SPECIFICATIONS AND DRAWINGS
HOUSING AUTHORITY OF THE CITY OF LUMBERTON: TURNER TERRACE
REPAIR OF FLOOD-DAMAGED UNITS
TWC # 3313-B 03

SUBJECT: ADDENDUM NO. 2

MAY 9, 2019

To the Plans and Specifications for:
Housing Authority of the City of Lumberton: Turner Terrace
Repair of Flood-Damaged Units

2 WINDOW TRIM DETAILS
SCALE: N.T.S.

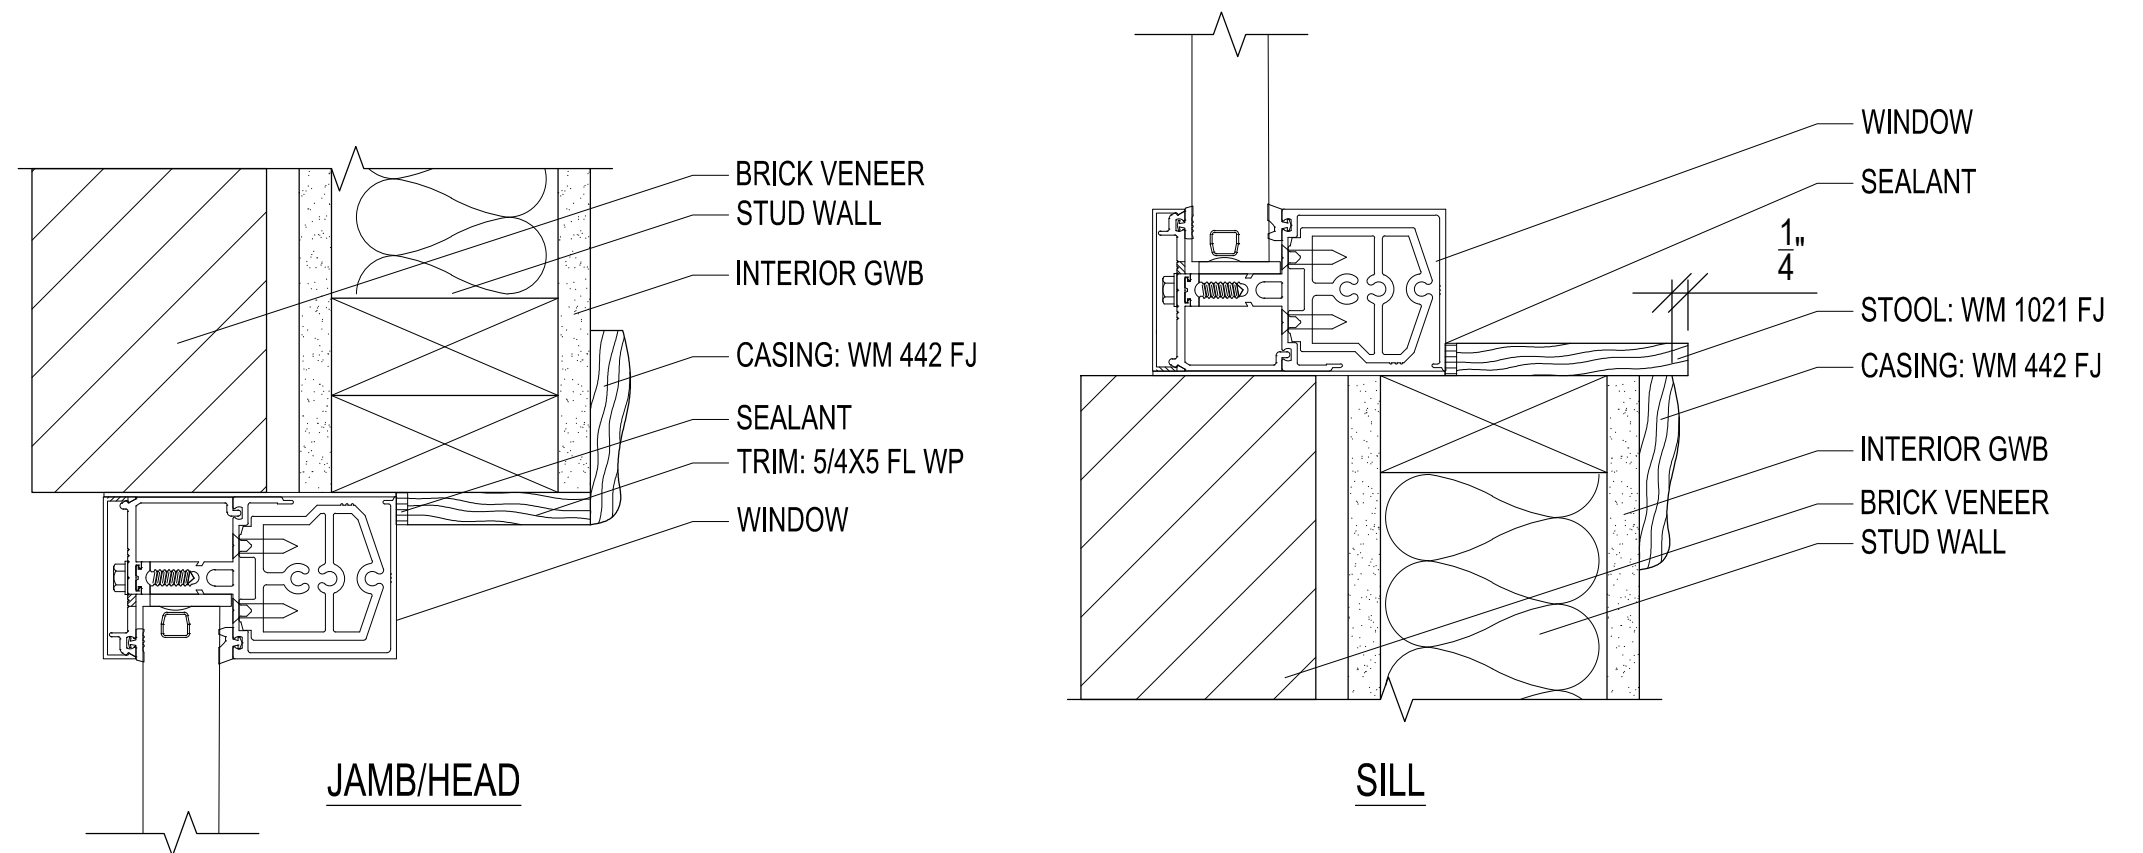
1. Sheet T1, Cover Sheet
 - a. Replace with attached.
 - b. Sheet List indicates sheets modified by this Addendum by Triangle-01.
2. Sheets A101-A105
 - a. Replace with attached.
 - b. Changes to General Notes indicated by Triangle-01
3. Sheet A402
 - a. Replace with attached.
 - b. 16/A402 has been added and indicated by Triangle-01.
4. Sheet A601
 - a. Replace with attached.
 - b. 2/A601 has been added and indicated by Triangle-01.

1 ELECTRICAL PLAN - UNIT "B"
 E101 SCALE: 1/4" = 1'-0"

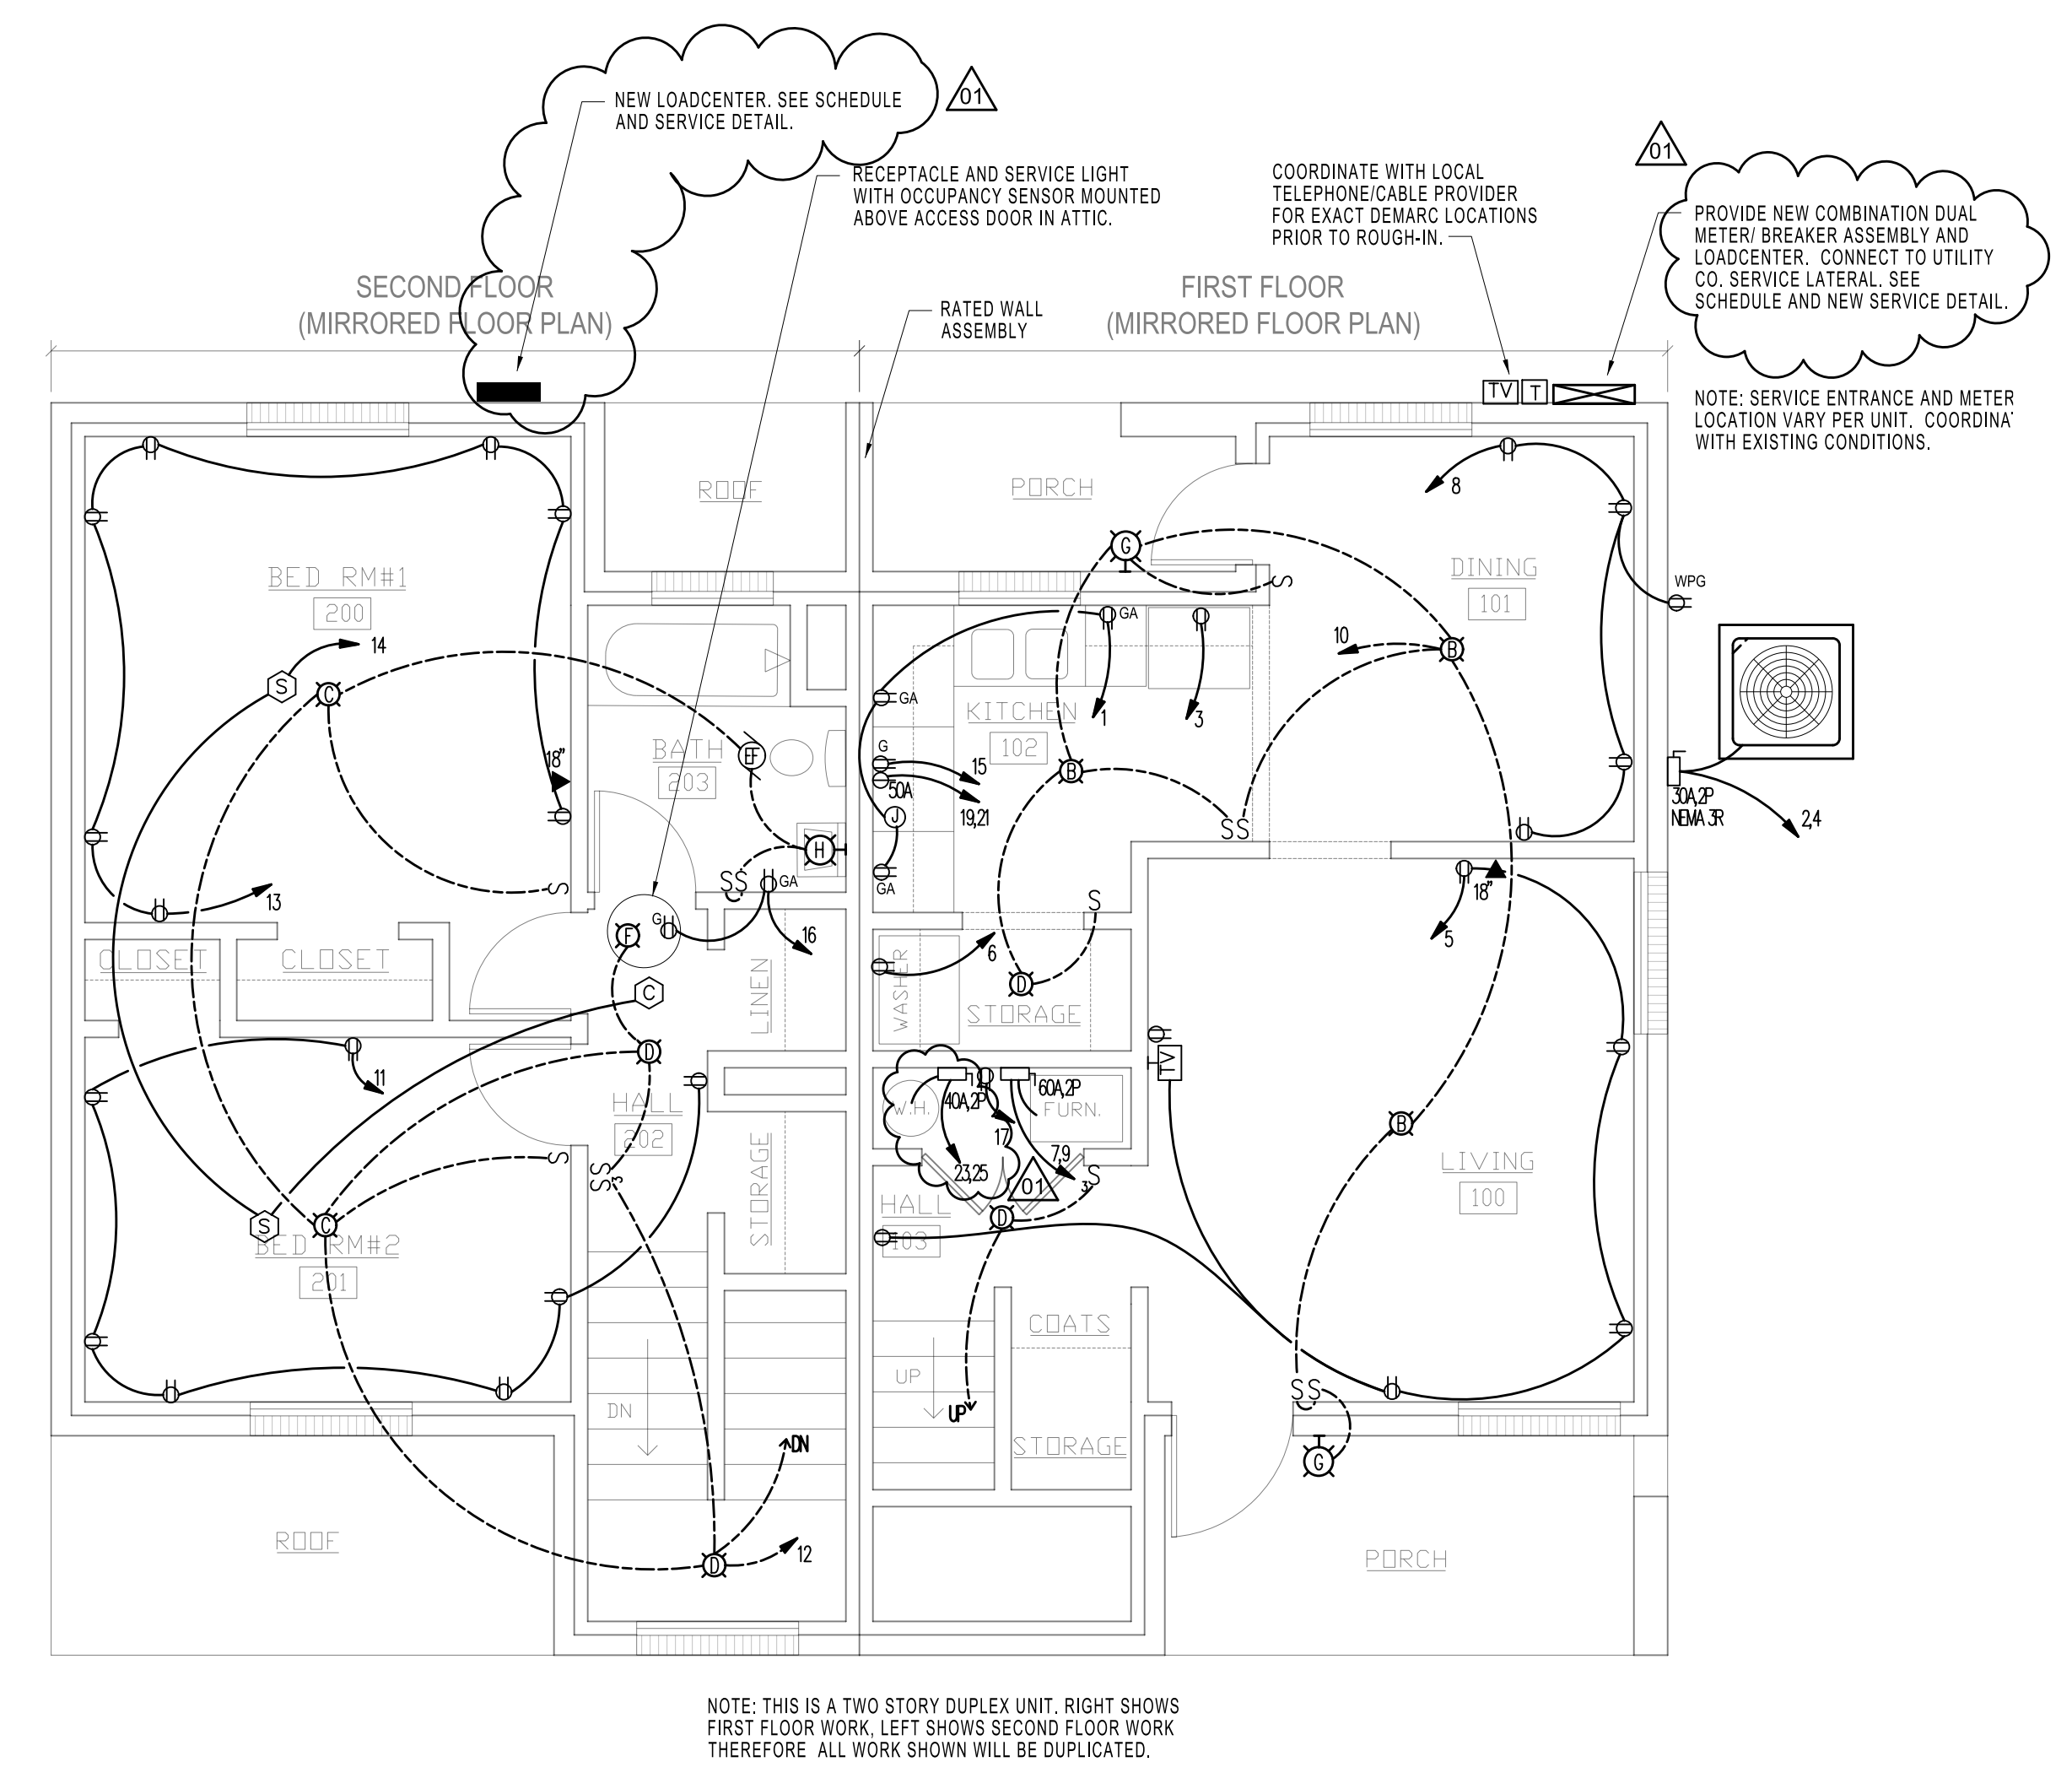
- b. 1/E101: Revise note for service entrance equipment.
 - c. Add separate loadcenter location for second unit.
 - d. Add circuits for electrical water heaters.

- e. 2/E101: Revise note for service entrance equipment.
 - f. Add loadcenter location for renovated unit.
 - g. Add circuit for electrical water heater.
